CITY OF TEMPE, ARIZONA
PUBLIC WORKS DEPARTMENT
DIVISION OF ENGINEERING

SALT RIVER OUTFALL CHANNEL, PHASE II
(48TH STREET DRAIN)
PROJECT NO. 75032

ADDENDUM NO. 2 TO CONTRACT DOCUMENTS

ADDENDUM NO. 1 TO CONTRACT DOCUMENTS

EXHIBIT A

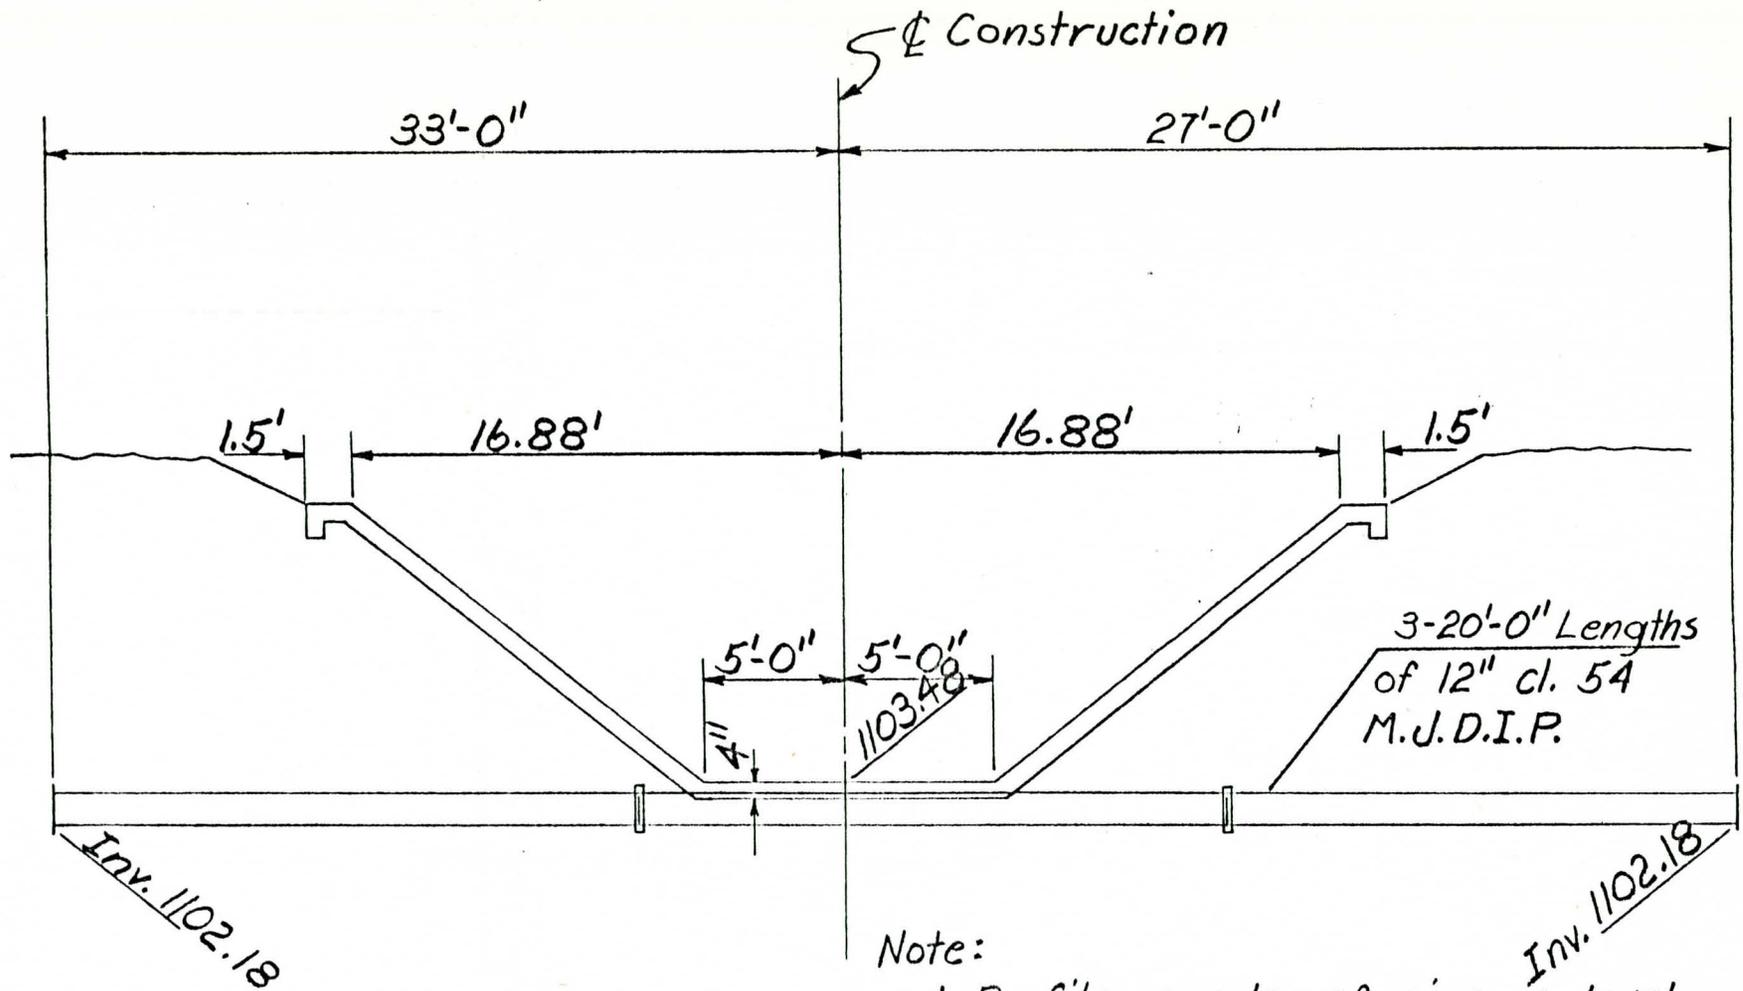
Sheet 7 of 35 of the plans, station 16+00, revise to include installation of 60 L.F. of M.J.D.I.P. per the attached Exhibit "A".

1. Profile grade of pipe is level.
2. Cap each end of pipe.
3. Pipe joints shall not penetrate conc. channel lining.

EXHIBIT B

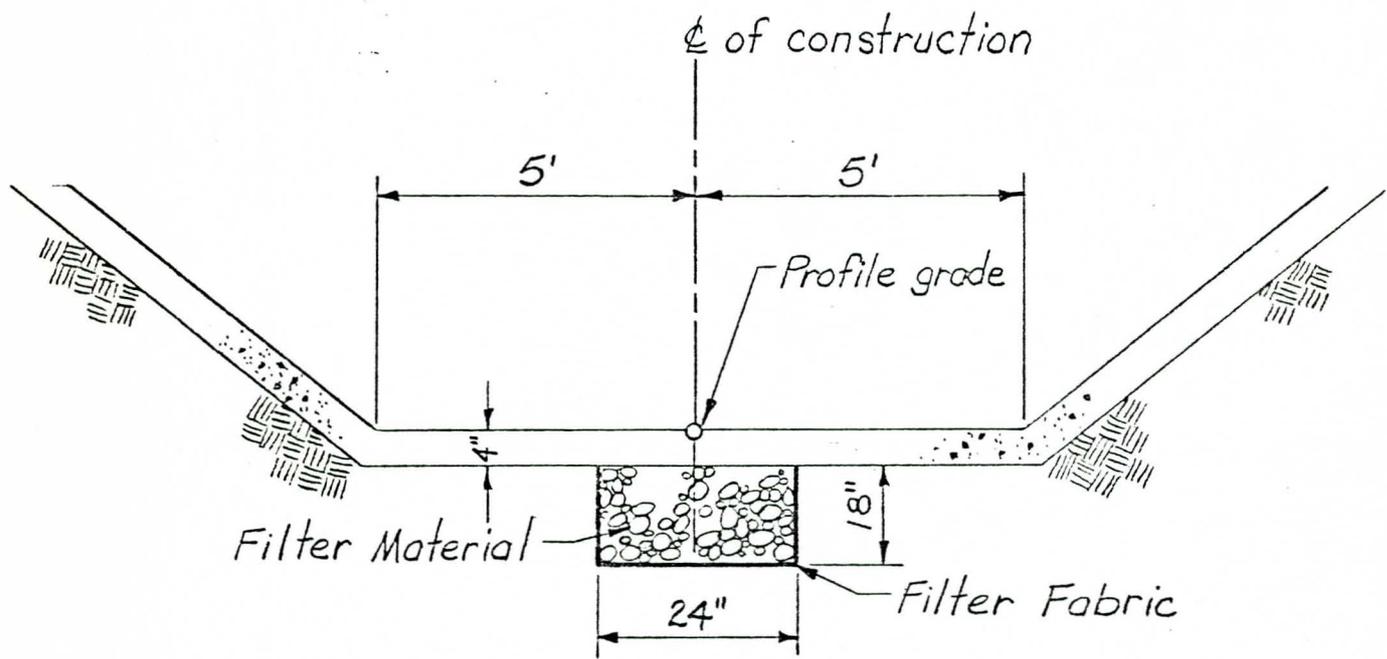
Sheet 3 of 35 of the plans, revise the Typical Channel Section to include the filter fabric per the attached Exhibit "B".
